Technical Bulletin

Section Title: Engine
 TSB No. TS 35 12103

SUBJECT: SPECIAL COVERAGE EXTENSION FOR SPECIFIC CRACK(S) IN THE CYLINDER HEAD.

MODEL(S): GRAND VITARA (JB) WITH 2.4L ENGINE

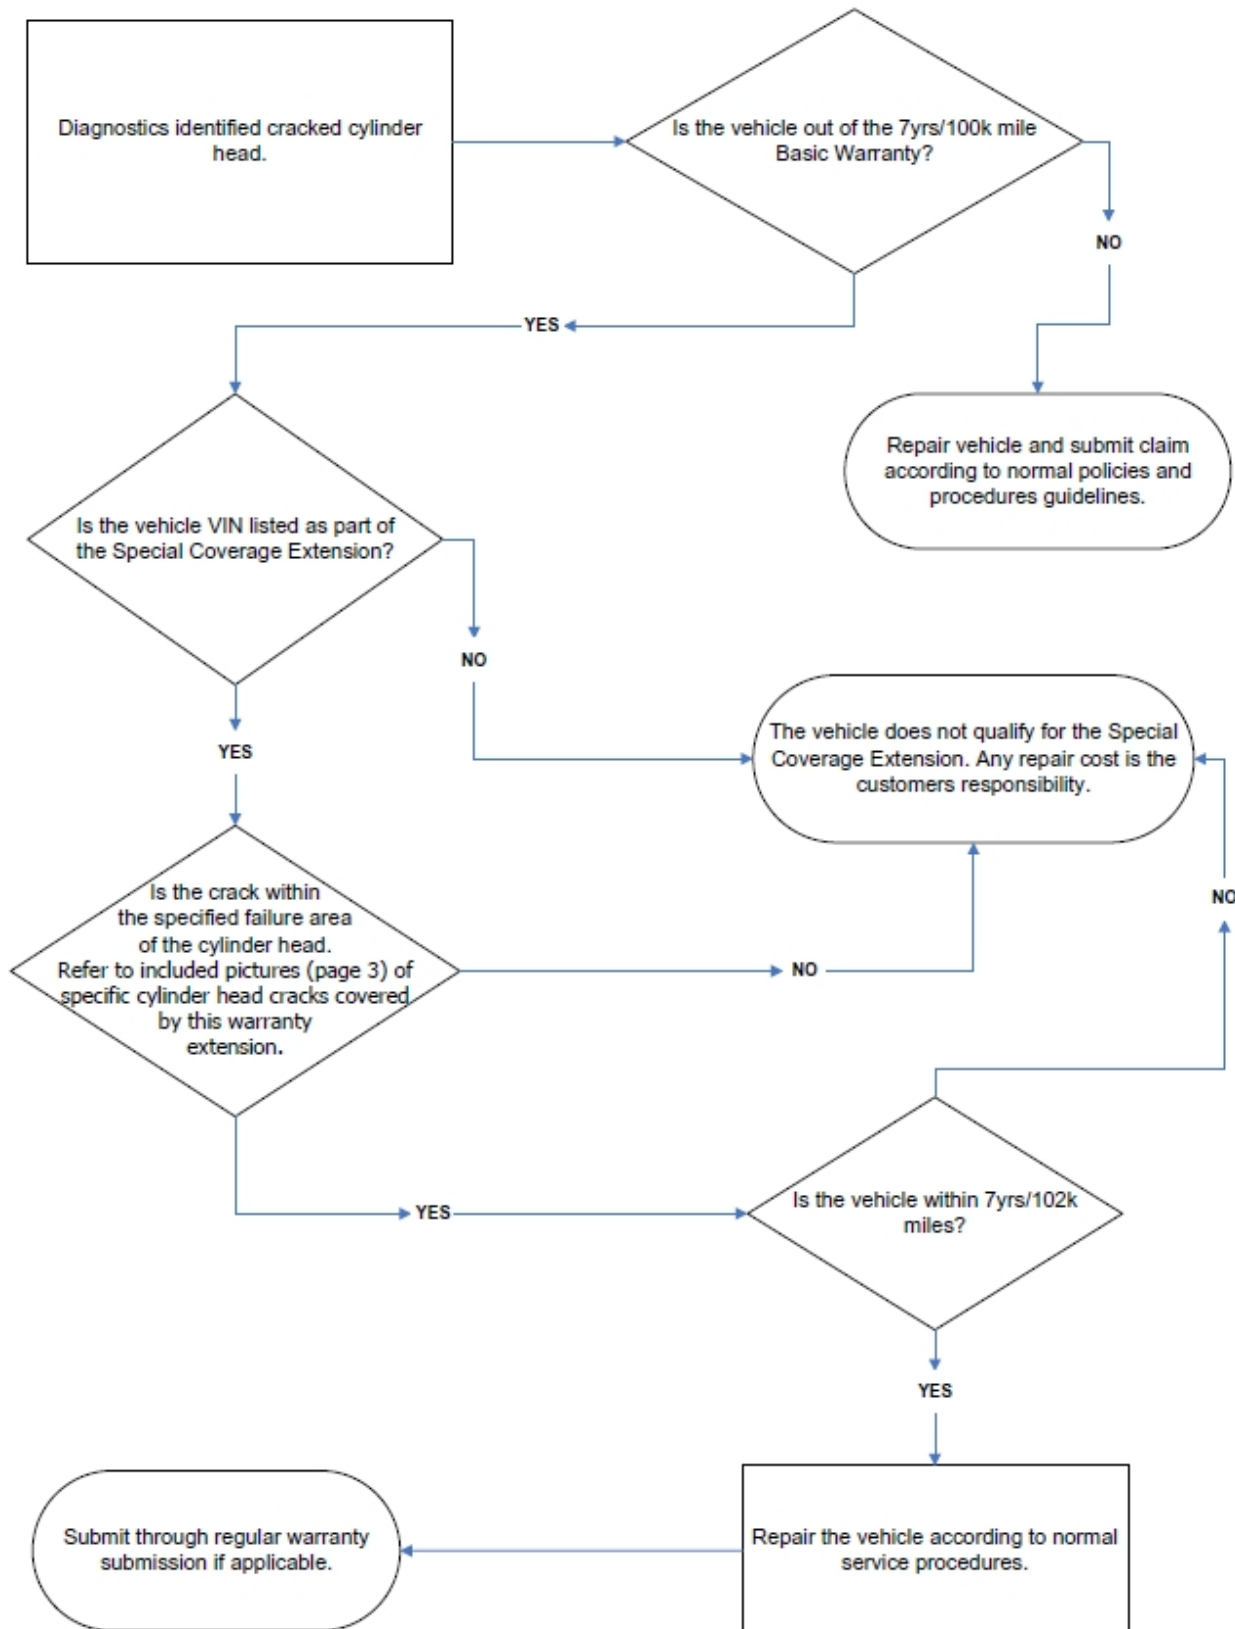
CAUSE: Suzuki has determined that certain 2009 Grand Vitara vehicles may develop a crack(s) between cylinder head bolt(s) and casting plug(s).

CORRECTION: A special coverage extension will apply for vehicles beyond the basic warranty limits. The coverage allows repairs to be made for customers at no charge for parts and labor up to 7 years or 102,000 miles, whichever comes first, from the date of first use, at authorized Suzuki service points. Cracks in locations other than the specified areas of the cylinder head do not qualify for the coverage extension.

FAILURE AREA

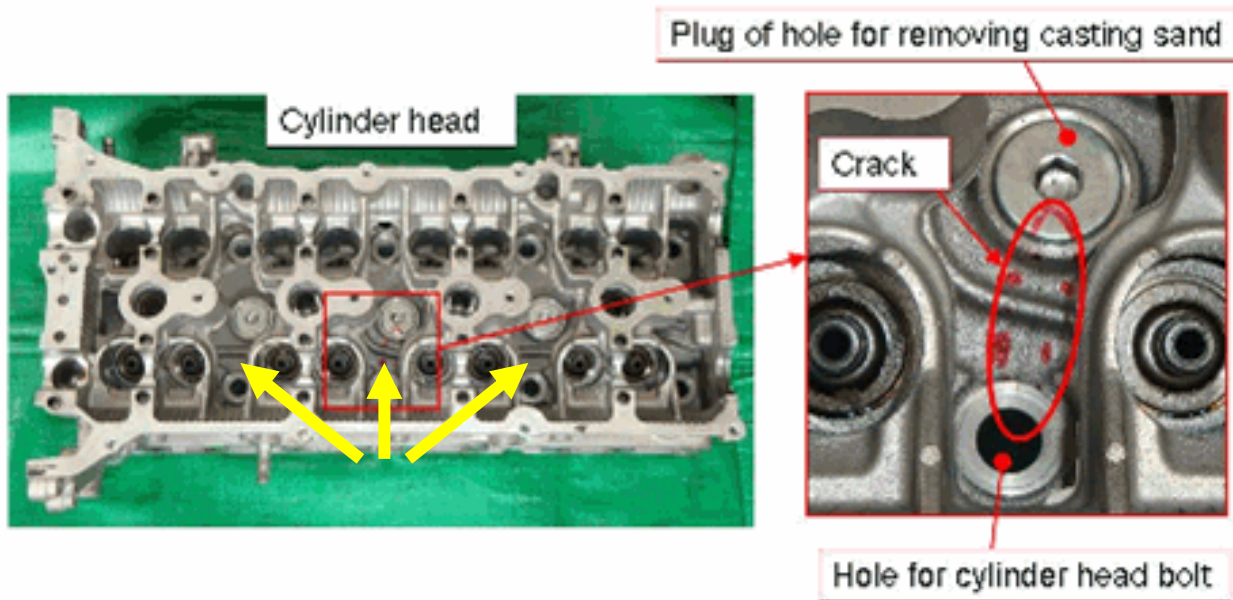
Cracks located in the 3 areas indicated by arrows may be eligible for coverage.
